Docket Item # 6
BAR CASE # 2008-0117

BAR Meeting
September 3, 2008

ISSUE: Signage

LOCATION: 1600 King Street

Figure 2: Double Faced Blade Sign Detail

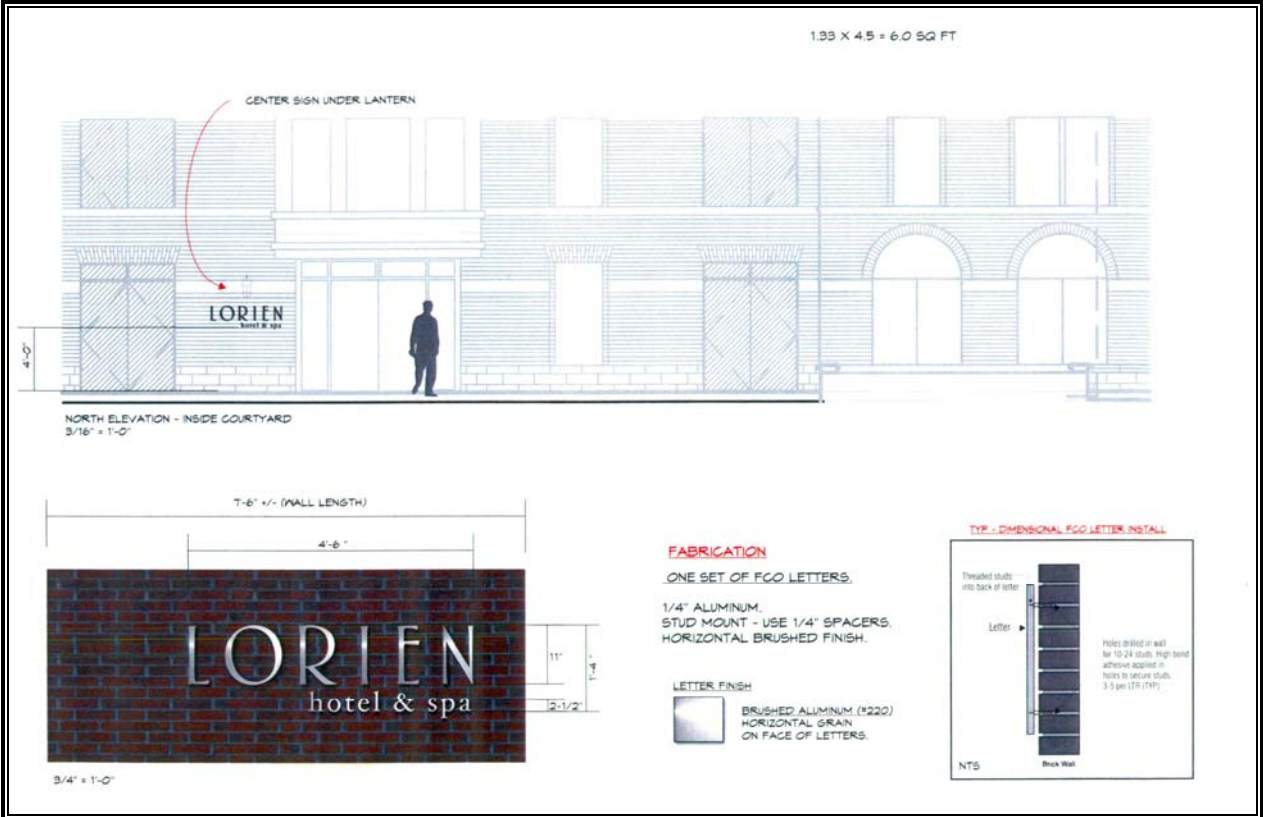
Another area of concern of Staff had been the projecting blade sign at the corner of the western remnant façade building. The applicant has reduced the size of the sign to an acceptable size, and Staff is now supportive.

- C-2 Projecting, hanging signs must comply with USBC [H103-H107, H112] for type of materials, maximum projection, vertical clearance below all parts of the sign, and additional loads.

Figure 3: Mounted Courtyard Sign

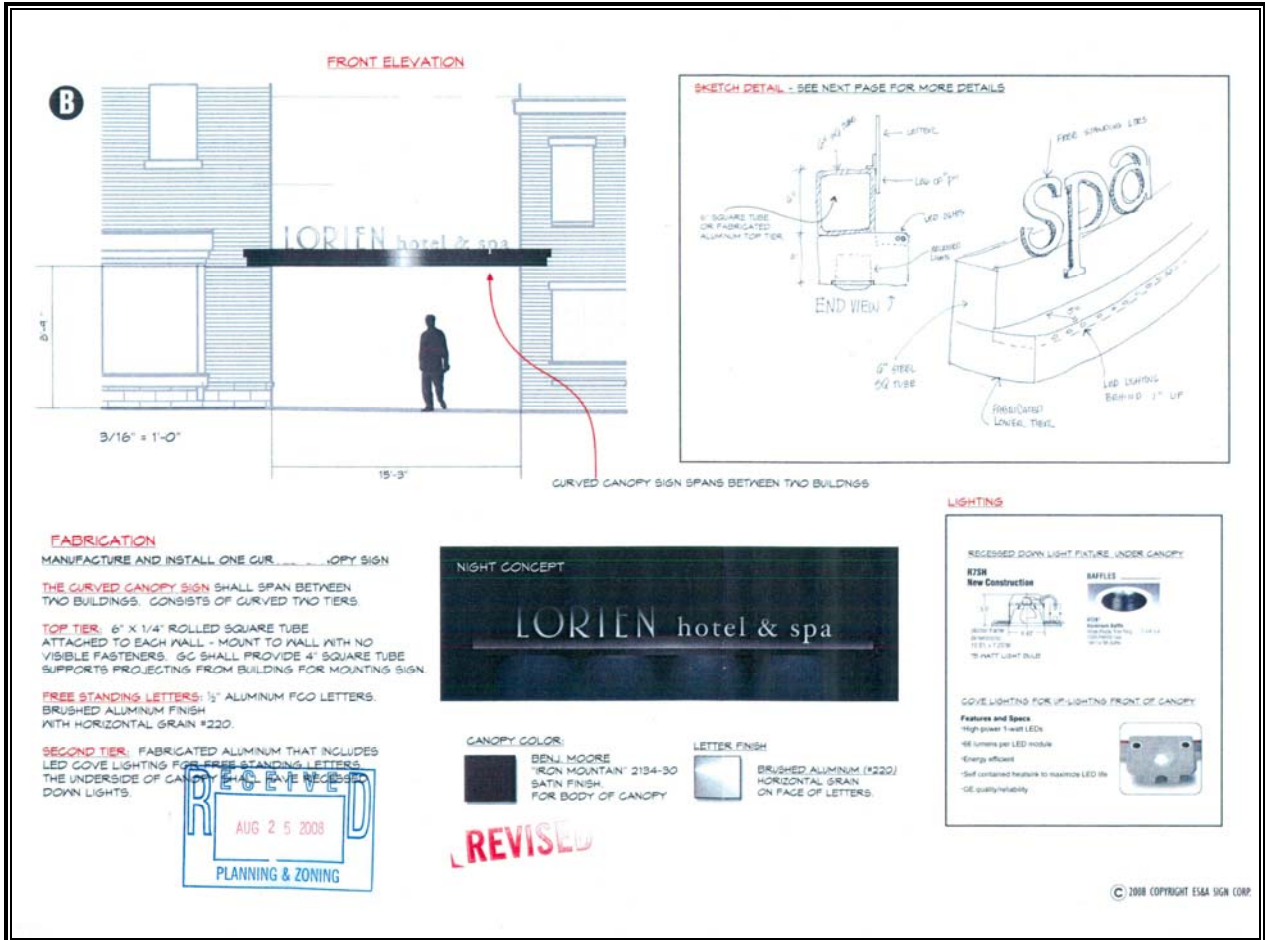
- F-1 The applicant shall obtain a sign permit for the proposed sign and/ or wall lettering.
- C-1 Wall letters / signs must comply with USBC [H103-H111] Please indicate the method to be used for anchoring the letters to the wall.

Figure 4: Canopy Sign

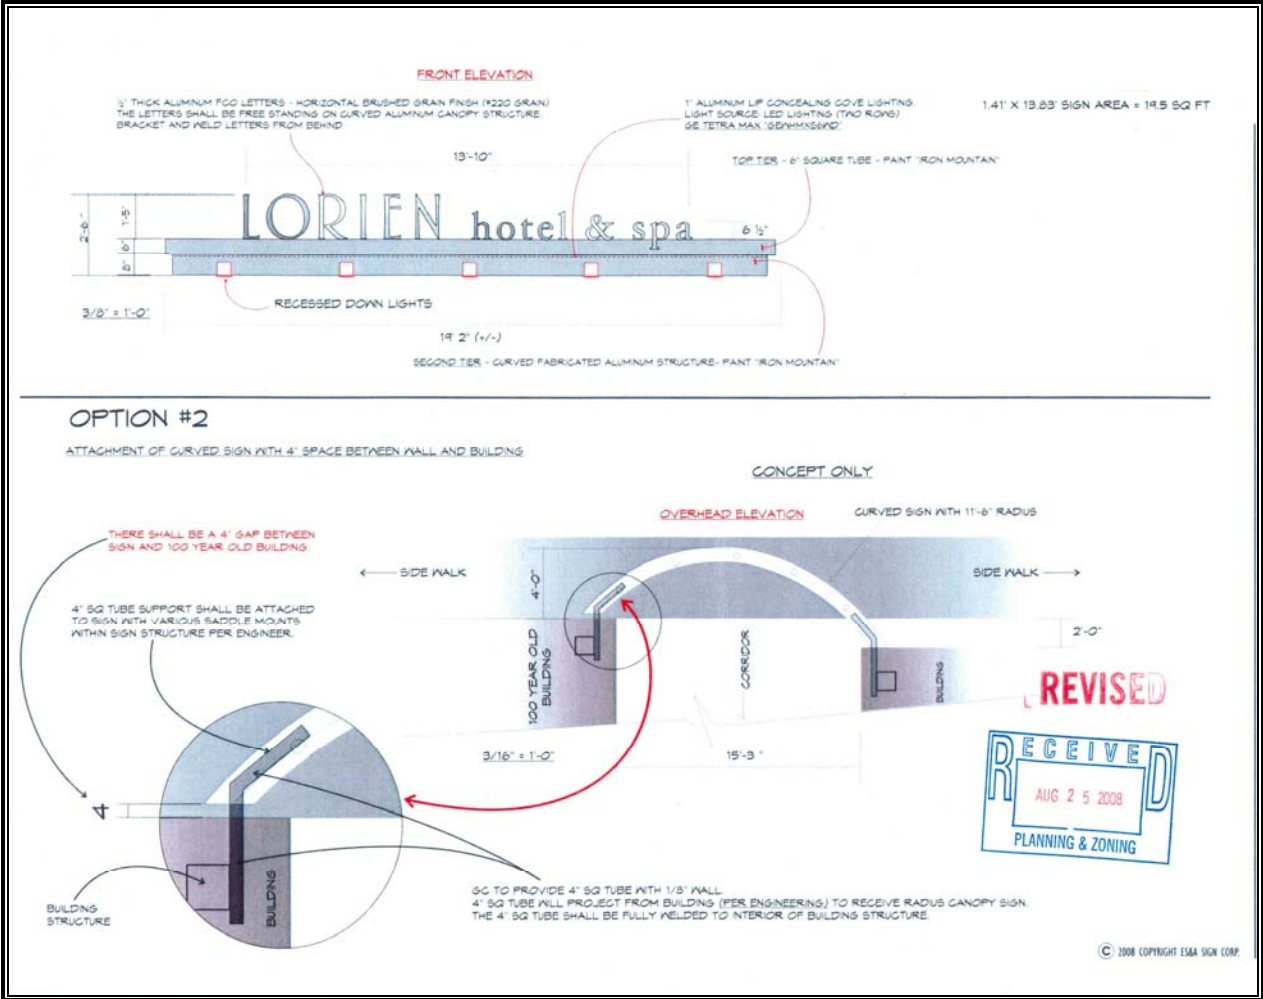
A particular concern of Staff has been the curved sign attached to the new eastern building and the 100-Year Old Building. Staff did not want this sign to negatively impact the 100-Year Old Building in its attachment, nor detract from the architectural characteristics of the building. The applicant has proposed to connect the sign with a 4” gap that provides a visual and physical break, which enables the 100-Year Old Building to remain largely unaltered. Therefore, the sign could be removed and the historic building appearance maintained and preserved. Staff reminds the applicant that the attachment should be through the mortar joint so as not to negatively impact the historic brick of the building.

- C-3 Canopies must comply with USBC 3202.3.1 for support and clearance from the sidewalk, and the applicable sections of USBC's Chapter 11. Structural designs of fabric covered canopies must comply with USBC 3105.3. The horizontal portions of the framework must not be less than 8 feet nor more than 12 feet above the sidewalk and the clearance between the covering or valance and the sidewalk must not be less than 7 feet.
